Subject: Shoreline Setback Variance (SSV)  
Chapter 343 Hawaii Revised Statutes (HRS)  
Revised Draft Environmental Assessment

Recorded Owner:	Kahn Family Trust
Applicant:	Philippe and Sonia Kahn
Agent:	Analytical Planning Consultants, Inc.
Location:	146 Wailupe Circle - Wailupe
Tax Map Key:	3-6-1: 38
Request:	Shoreline Setback Variance
Proposal:	The revised proposal includes the construction of a new, two-foot high CRM retaining wall mauka (landward) of the seawall, with an approximately three-foot wide planting and/or terraced area between the two walls, including excavation and backfilling to the top of the two-foot high CRM wall (landward) to match the existing grade of the yard.

**Subject:** 146 WAILUPE CIRCLE SEAWALL - ADDENDUM TO FINAL  
ENVIRONMENTAL ASSESSMENT SHORELINE SETBACK VARIANCE  
APPLICATION FOR A SEAWALL TMK: (1) 3-6-001:038.

**Kahn Residence**  
Sea Wall Repair  
146 Waiupe Circle, Honolulu, Hawaii  
TMK: 3-6-001-038

Wall Sections  
S-1 Wall Sections Revised 8/14/12

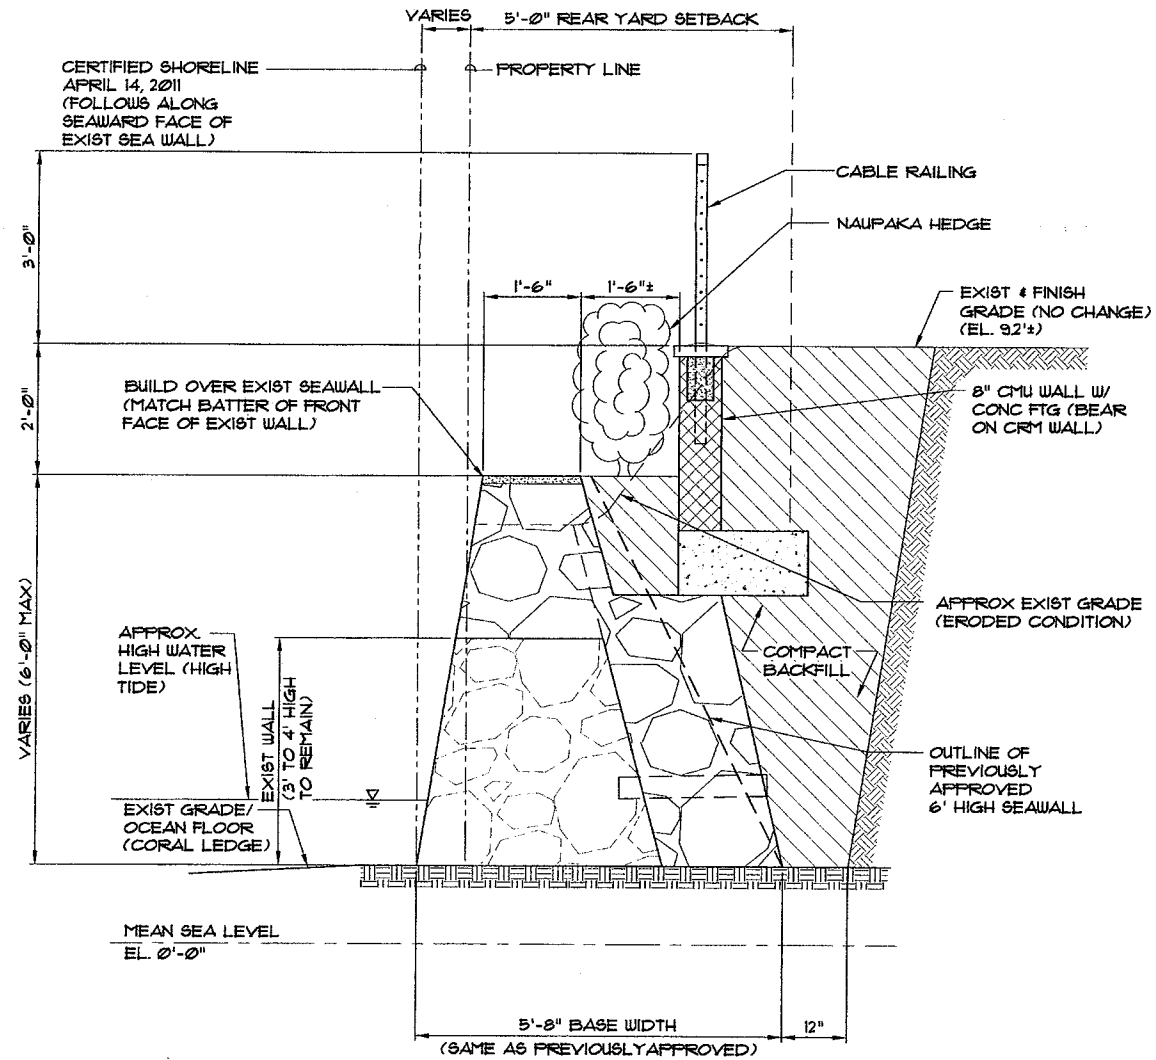
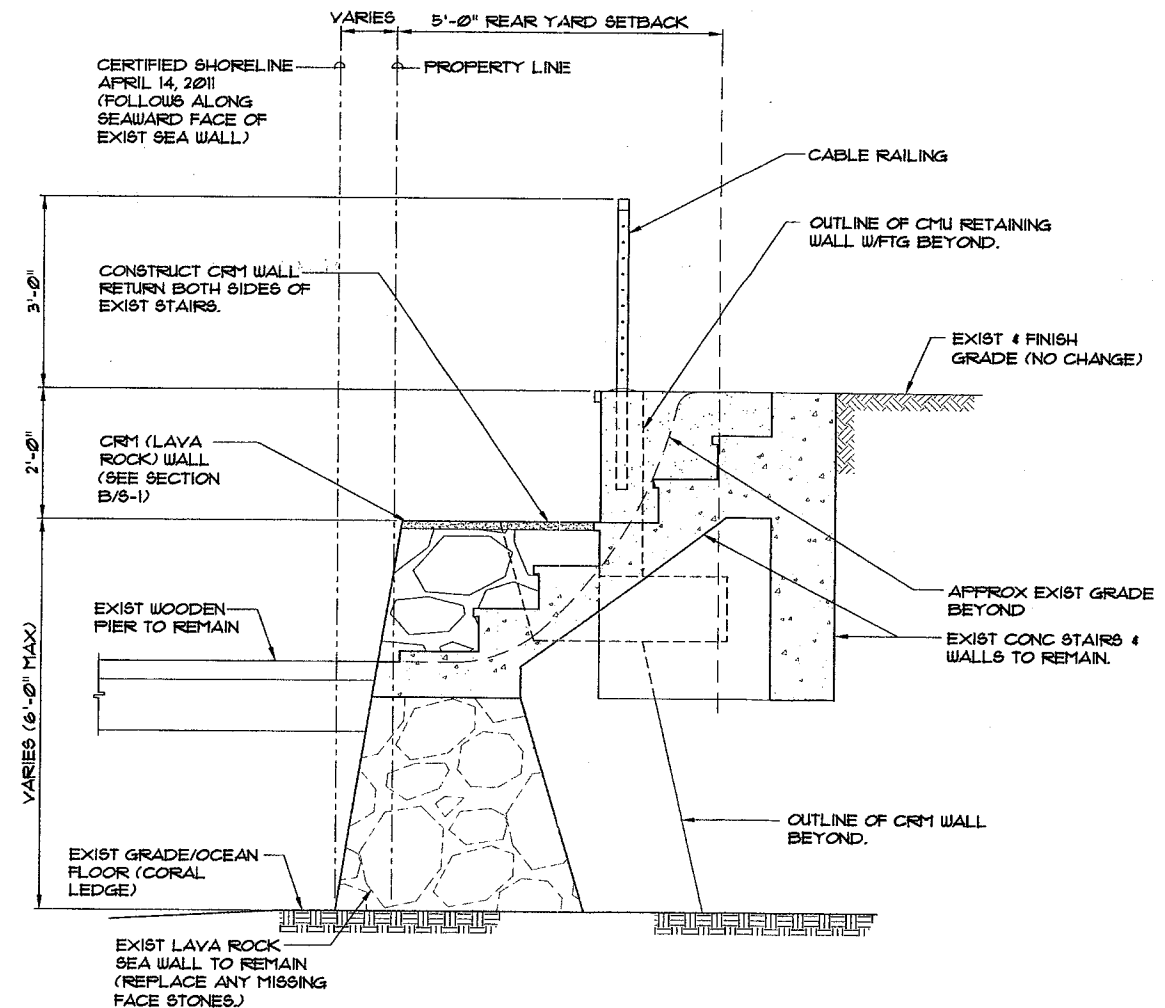
The proposed seawall design has been revised to limit the height of the seawall to 6 feet per DPP comments. Since the existing lot grade is approximately 8 feet above the ocean bottom, a 2 feet tall CMU retaining wall has been added landside of the seawall to retain the balance of the lot. The proximity of the added CMU wall causes an increase in active earth pressure imposed upon the seawall (surcharge) and therefore, the CRM wall section required widening to maintain lateral stability (the ledge) The contribution of weight of the CMU wall, which bears on the widened CRM wall, was considered in the seawall structural design in order to minimize the increase in wall cross section. Increasing the wall thickness was the only possible option available as removing any portion of the underlying historic fishpond wall to provide embedment below the ocean bottom was prohibited. The approximate increase in CRM volume is 7.6% with an increase in weight on the foundation of 50 lbs/ft of wall or 1.7%.

- Revised architectural plans showing the 2-foot wall and return walls (A-1.1-2, A-2.1-2)
- The plans included in the FEA showed the repaired wall to be 8-feet high and 5.5-feet in width at the base. The new plans show the wall to be 6-feet high and 5'8" in width (as approved by the DPP).

- The mauka portion of the 6-foot high seawall will be increased slightly to accommodate a ledge to support the 2-foot high retaining wall and landscape area.

- The top of the 6-foot seawall will be reduced in width from 1'8" to 1'6".
- The 3-foot high cable railing will be placed upon the 2-foot high retaining wall instead of the seawall.

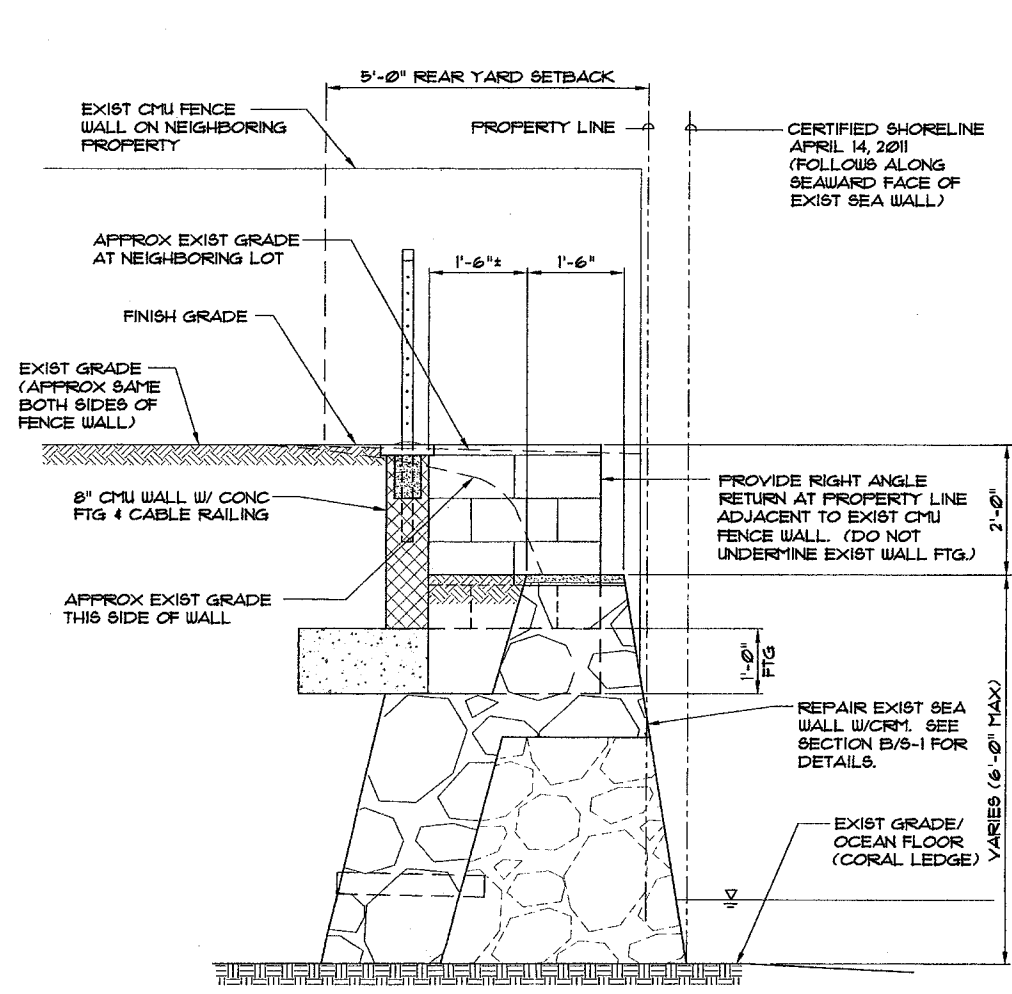
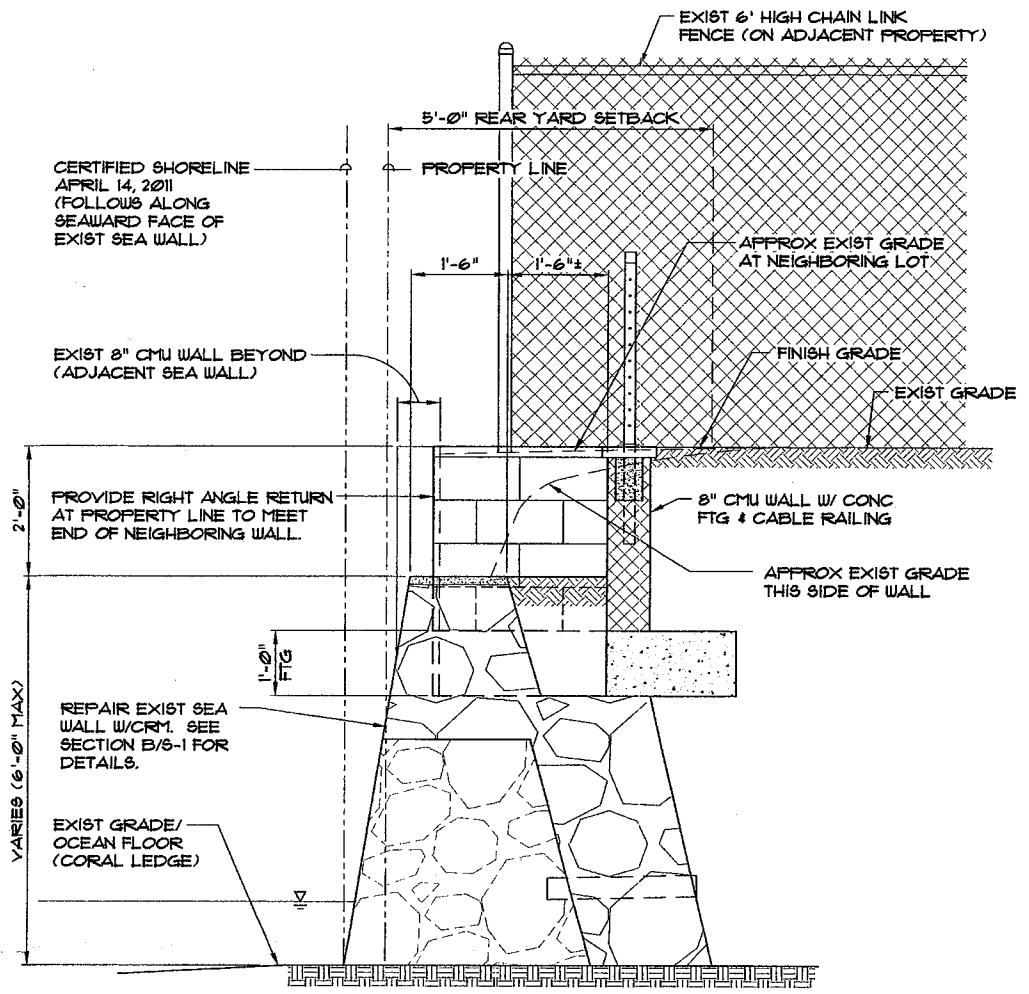
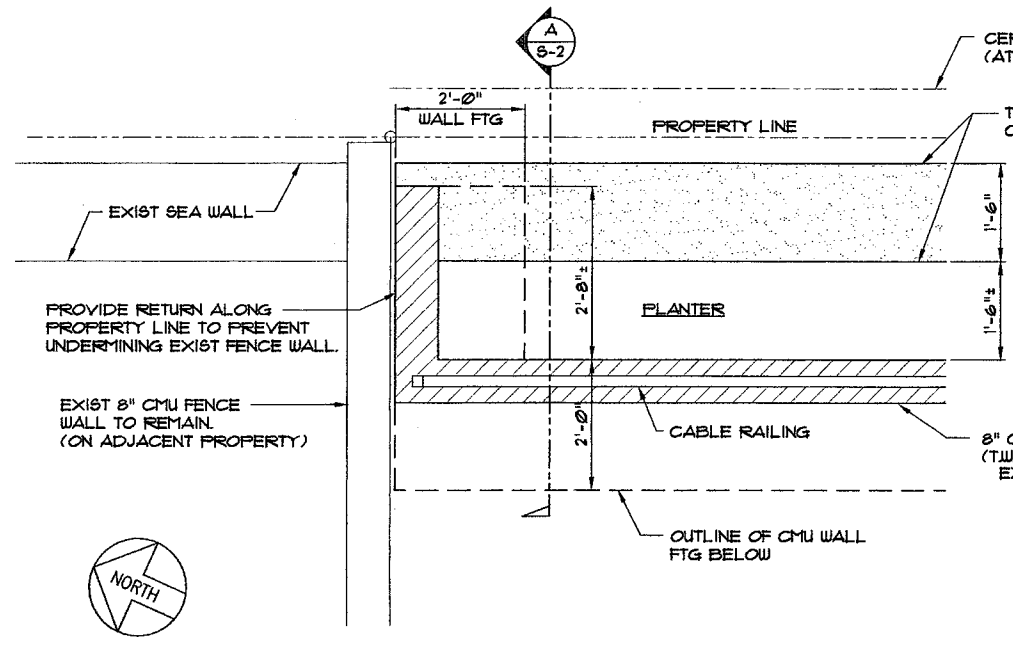
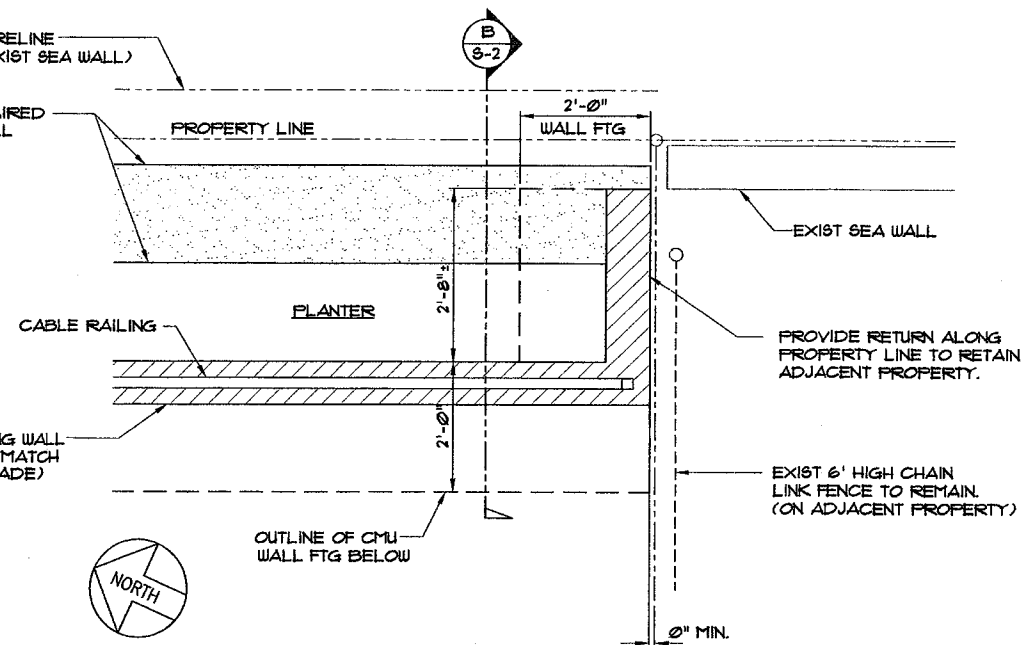
The adjacent lots at the north and south property lines are at approximately the same elevation as this lot. Since the CRM seawall was limited to 6 feet tall, right angle returns were provided at each end of the CMU wall. The return at the north end is required to prevent undermining of the neighboring CMU fence wall, and the return at the south end is required to retain the neighboring lot and prevent erosion at that corner. The length of the returns will not project beyond the top of the CRM seawall below.

- A 2-foot high retaining wall will be placed behind the 6-foot high seawall to protect the rear yard from additional erosion.
- New engineering plans S-1 & S-2.
